Product Change Notice

Replace L4 component with a resistor jumper

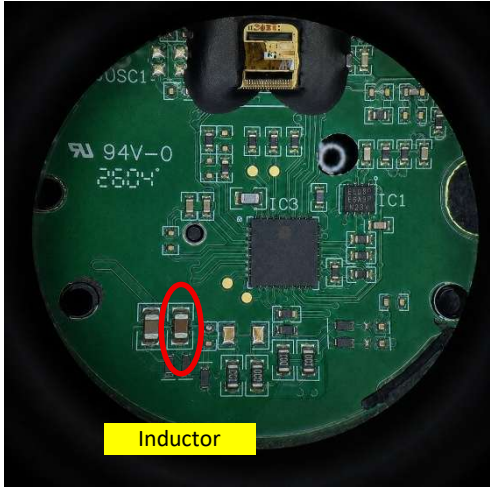
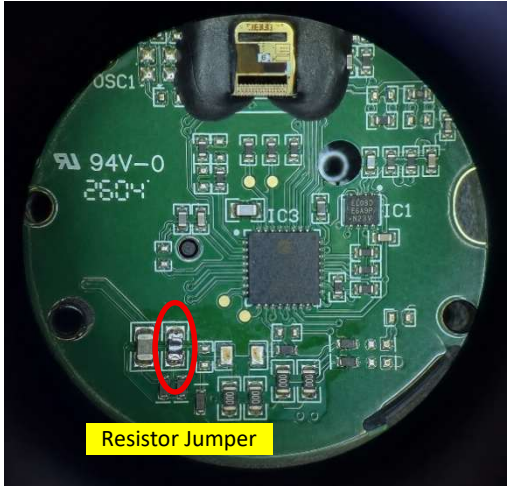
Current part	New part
 Inductor L4 : Inductor	 Resistor Jumper L4 : Resistor Jumper

Remove L4 and replace it with a resistor jumper to improve encoder's communication stability.
